Access Compliance Report

Public Rights-of-Way (Curb Ramps)

Intersection ID: 50651	Main Street: PINE_GLEN_CT	Cross Street: PINE_TERRACE_CT	Location:	N
ADA ID: A92F0AEAB759	Ramp Type: PerpDiag	Initial Pass/Fail: Fail	Overall Compliance: No	Severity Score: 25
Codes/Mitigation Info/Possible Solution		Field Measurements/Component Compliance

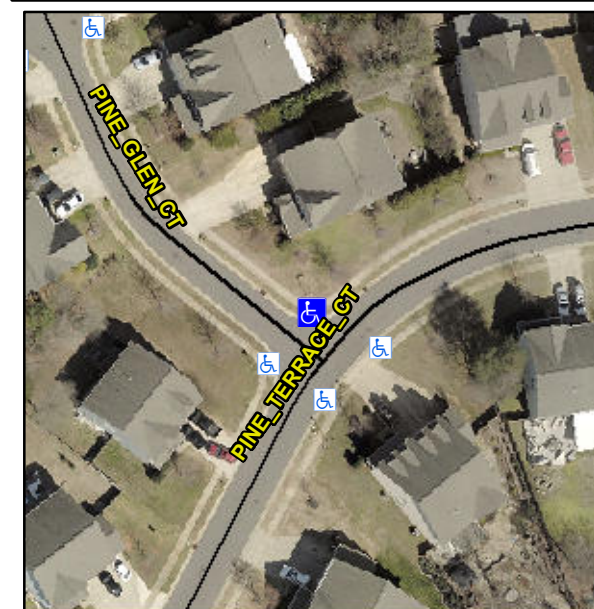
R304.2.2, R304.5.3

Compliance	Description	Data	Compliance	Description	Data
N/A	Ramp Length (in)	48.5	No	Ramp Slope (%)	8.4
Yes	Ramp Width (in)	48.0	No	Ramp XSlope (%)	5.1
N/A	Flare Type LT	N/A	N/A	Flare Type RT	N/A
N/A	Flare Slope LT (%)	N/A	N/A	Flare Slope RT (%)	N/A
N/A	Flare Traversable LT?	N/A	N/A	Flare Traversable RT?	N/A
N/A	Landing Length (in)	N/A	N/A	DWS Provided?	N/A
N/A	Landing Width (in)	N/A	N/A	DWS Contrast?	N/A
N/A	Landing Slope (%)	N/A	N/A	DWS Length (in)	N/A
N/A	Landing X Slope (%)	N/A	N/A	DWS Full Width?	N/A
N/A	Landing Curb? (Y/N)	N/A	N/A	DWS Offset (in)	N/A
N/A	Shared Landing?	N/A			
N/A	Gutter Ponding?	N/A	N/A	Gutter Slope (%)	N/A
N/A	Gutter Lip Ht (in)	N/A	N/A	Gutter X Slope (%)	N/A
N/A	Painted X Walk1?	No	N/A	Painted X Walk2?	No
	X Walk 1 Direction	To SW		X Walk 2 Direction	To SE
N/A	X Walk 1 Width (in)	N/A	N/A	X Walk 2 Width (in)	N/A
	X Walk 1 Slope (%)	3.1		X Walk 2 Slope (%)	0.9
	X Walk 1 X Slope (%)	1.7		X Walk 2 X Slope (%)	2.7

Remove & Replace Curb Ramp With Two New Directional Ramps or Equivalent.
